SHARON'S ORCHARD ADDITION DRAINAGE

REFERENCE Drainage Plan

STAFF REPORT
(Preliminary Plat)

CASE NUMBER: S/D 89-82 - SHARON'S ORCHARD ADDITION

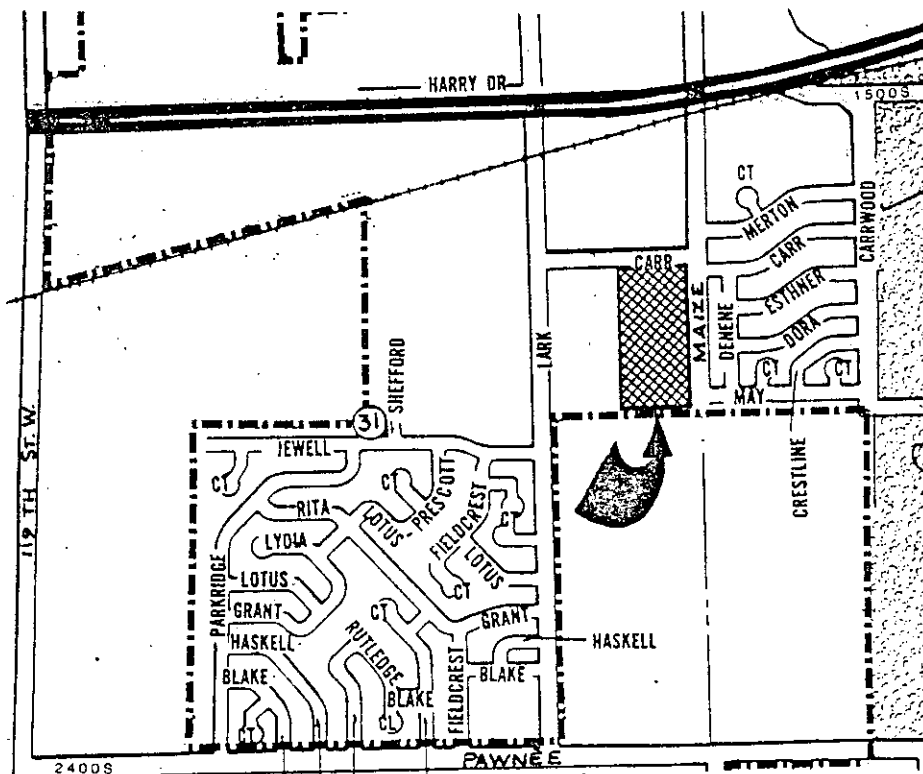
NOTE: In 1978 a proposed plat, Prairie Park 3rd Addition, with the same boundary as this preliminary plat, Sharon's Orchard Addition, was submitted and later approved by the MAPC at their December 7, 1978 meeting but was never scheduled for the City Council. During deliberation of Prairie Park 3rd Addition the plat was revised a number of times. Central to the various revisions was issues relating to two cul-de-sac streets intersecting with Maize Road. What is proposed today for the same area only aggravates concerns expressed back in 1978. The plat, as approved by the MAPC proposed 54 lots, none with direct access to Maize Road and created only one additional intersection.

The preliminary plat under review today, Sharon's Orchard Addition, would create two 500-foot cul-de-sac streets and two residential lots having direct access to Maize Road, but with typical 60-foot wide lots. This preliminary plat would permit 67 lots, rather than the 54 proposed in 1978.

The typical lot width of Prairie Park 3rd was 70-feet. We estimate that if Sharon's Orchard Addition adopted the street layout plan as was approved in 1978, but with 60-foot wide lots, the applicant could achieve perhaps as many as 68 lots, or approximately the same in number of lots proposed by the present plat.

- A. The Planning Department recommends the applicant submit a revised preliminary plat taking into account the above suggested changes. The following comments are made providing that no street layout changes are made.

- I. Central Inspection has informed us that the two "Maize Courts" pose street addressing difficulty and has requested that the two courts be renamed Esthner Circle and Dora Circle. The street between Lots 9 and 14 should be named "Esthner Court."

- J. The applicant shall convey complete access control across the east line of Lots 6, 27, 28, 47, 48, Block 1 and Lot 10, Block 2 to the City of Wichita. Lots 4 and 5 shall both convey access control to the City of Wichita, except each lot shall have one opening to Maize Road. The face of the plat and the plattor's text shall make the appropriate notation.

- K. The applicant shall dedicate 7-feet of street right-of-way from the west line of this plat for Stony Point Lane. The final plat shall also indicate complete access control for Lots 17, 18, 37, and 38, Block 1. The face of the plat and the plattor's text shall make the appropriate notation.

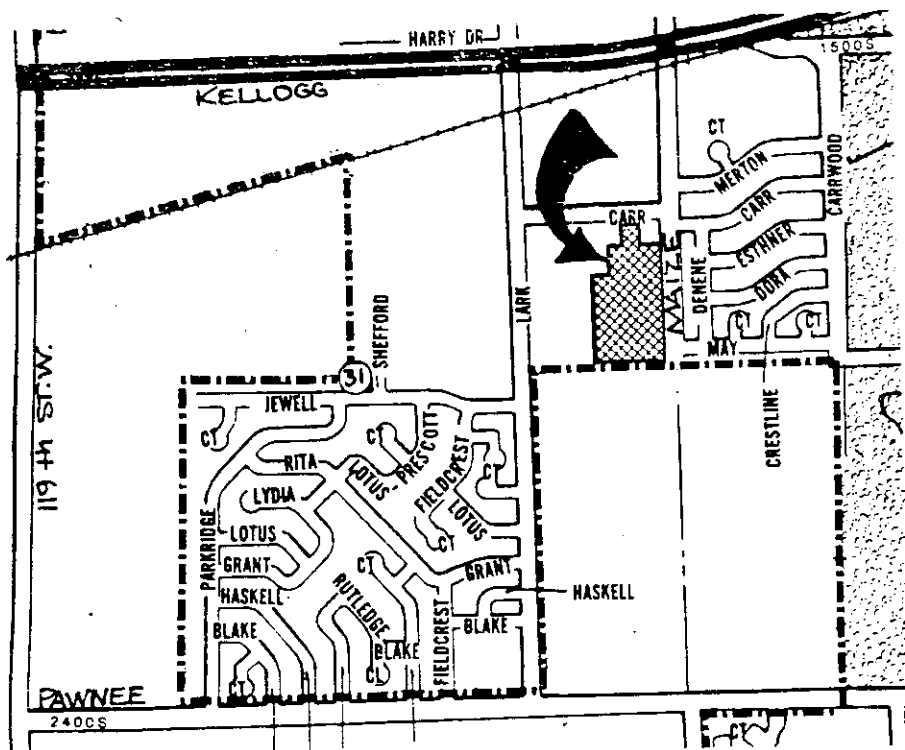
- H. The applicant shall submit a covenant which provides for four (4) off-street parking spaces per dwelling unit on each lot which abuts a 58-foot street. The covenant shall inventory the affected lots by lot and block number and shall state that the covenant runs with the land and is binding on future owners and assigns.

- I. The centerline of Maize Road shall be clearly indicated on the final plat tracing.
- J. On the final plat tracing, the 15-foot utility easement on the west line of Lot 1, Block 2 and Lot 57, Block 1 shall be labeled as a "15-foot utility easement and building setback."

- K. On the final plat tracing, the platator's text should convey complete access control for Lot 48, Block 1; not Lot 49.
- L. The legal description given in the surveyor's text and that which is found in the title report are different. The Surveyor shall submit a letter to the Planning Department, with the final plat tracing, stating that the legal description in both documents describe the exact same tract of land.
